RE: Response to Technical Evaluation Comments and Information Request of CES's Responses to EPA's Initial Technical Evaluation Comments and Information Requests #1-4 CES-Mendota Site Underground Injection Control (UIC) Permit Application Class VI Pre-Construction Permit Application No. R9UIC-CA6-FY20-1

### Evaluation of Applicant Responses to EPA’s Technical Review Comments on the Geologic Information in the CES-Mendota Class VI Permit Application

Figure 7. Upscaled porosity profile along the N-S cross-section.

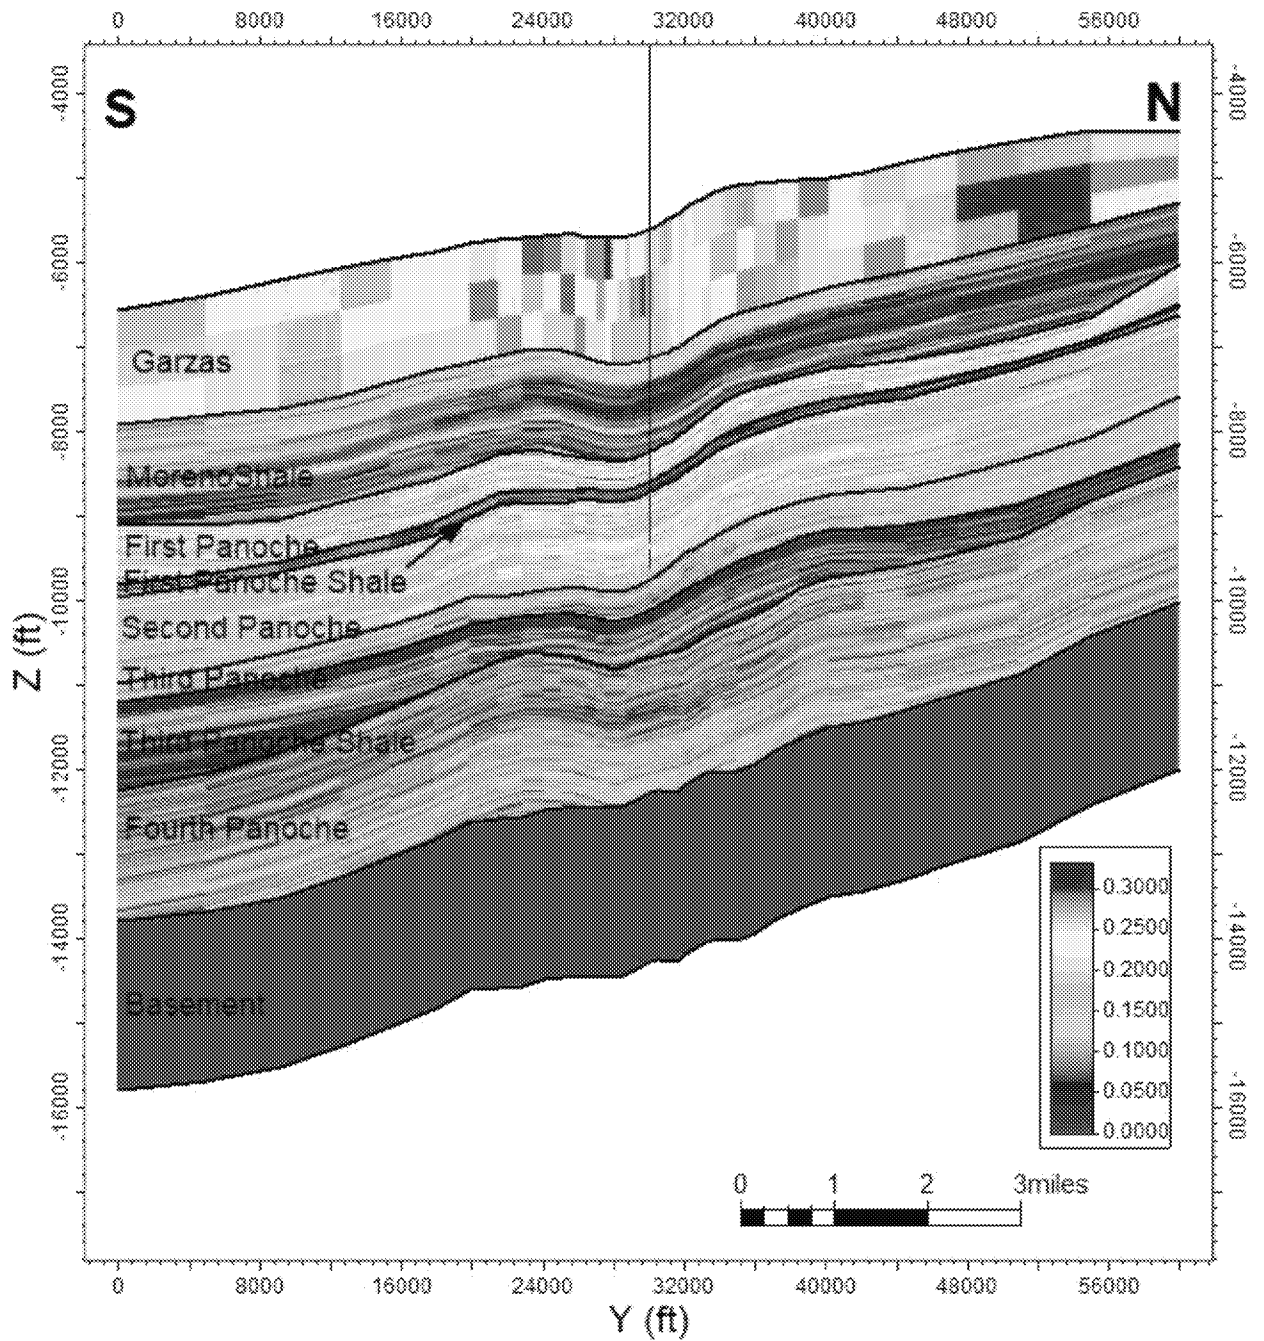
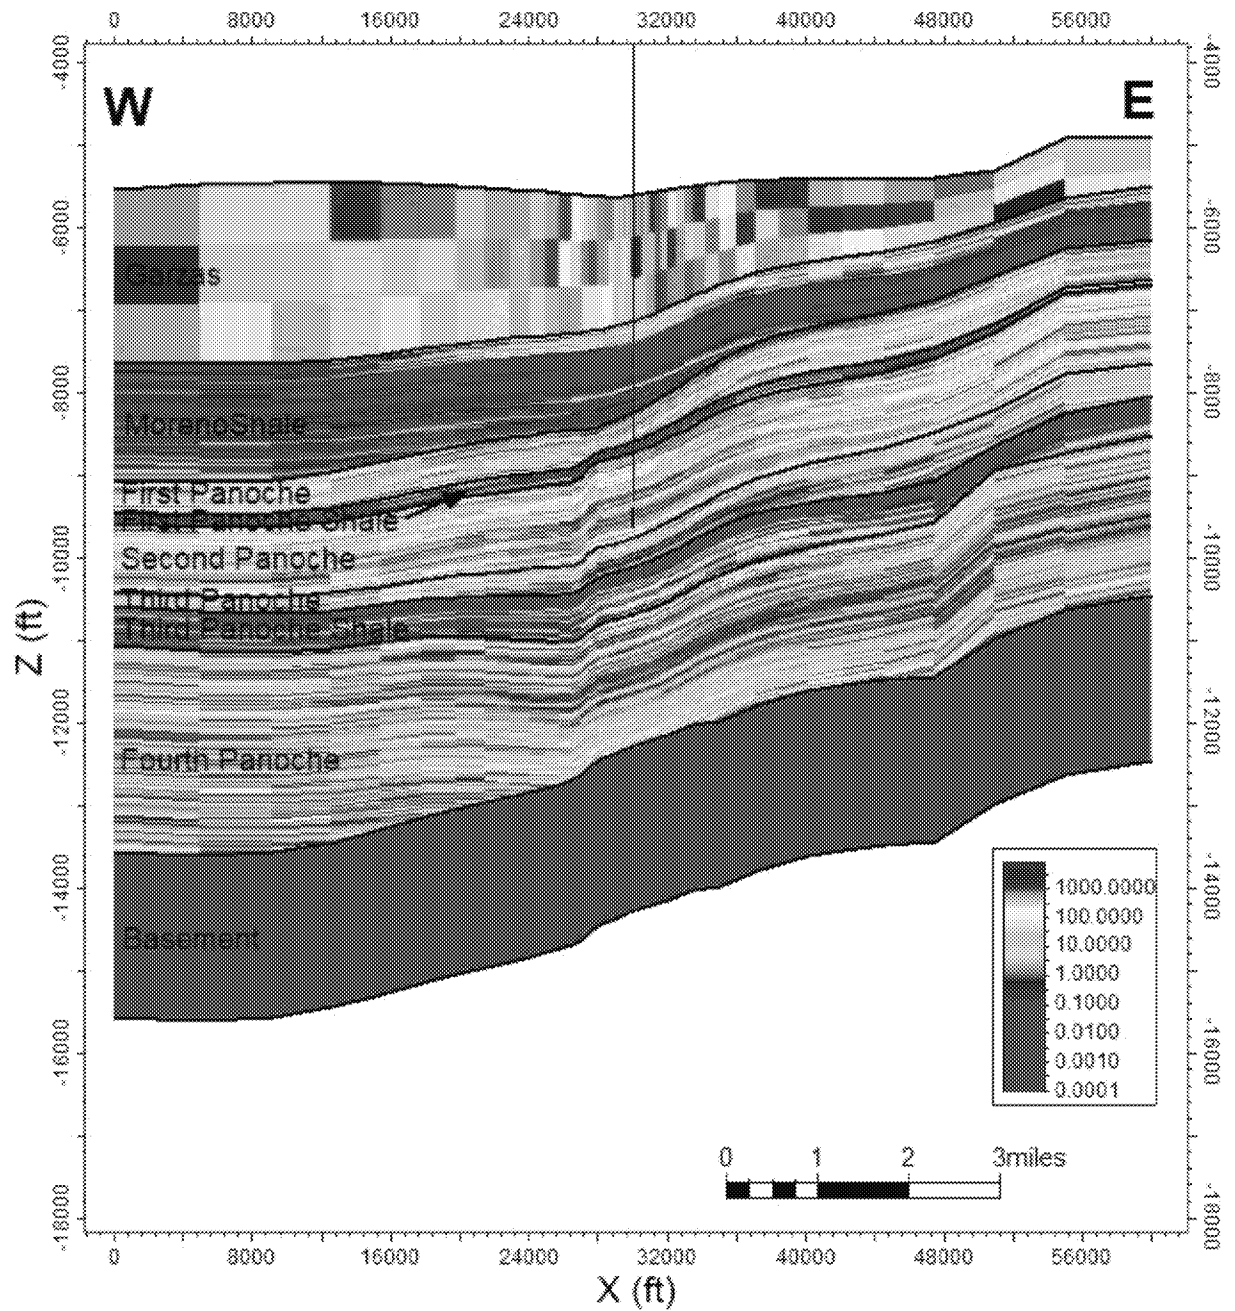
2.3.1	“The upscaled porosity and permeability graphics in Attachment B (Figures 3 and 4) would benefit from labeling for formation tops.”	<i>The figures were updated with formation tops in Figure 7 and Figure 8 (refer to Appendix A).</i>

Figure 14: BB Co. 1 wellbore after P&A operation

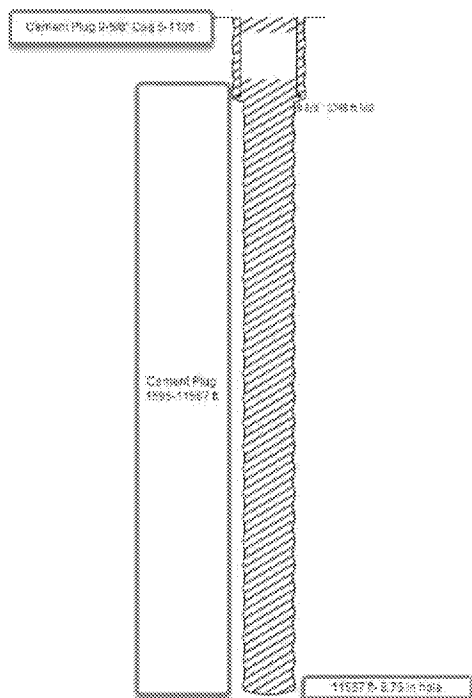
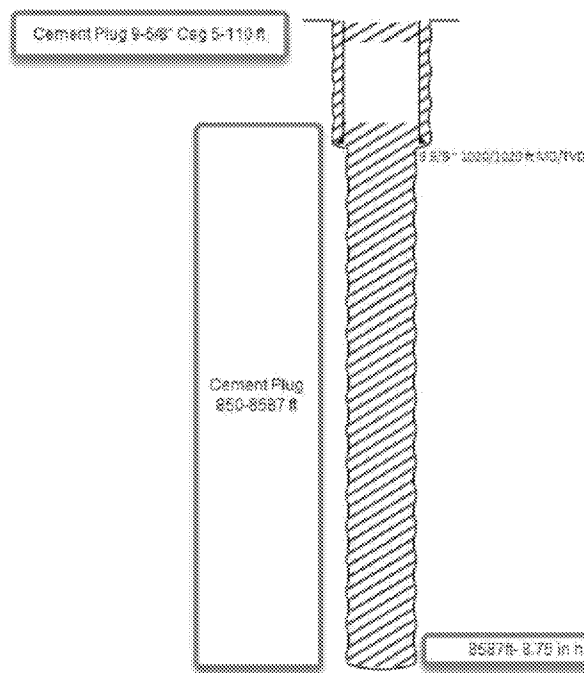
- *The plugging procedures for Amstar 1 and BB Co 1 on pages 25 and 26 reference a casing diameter of 9 5/8 inches; however, figures 14 and 15 show that the hole is 8.75 inches. Please clarify the discrepancy.*
- *This is correct. The 9 5/8-in. surface casing has drift inner diameter of 8.75 in. Therefore, an 8.75-in. hole was drilled below the 9 5/8-in. casing.*
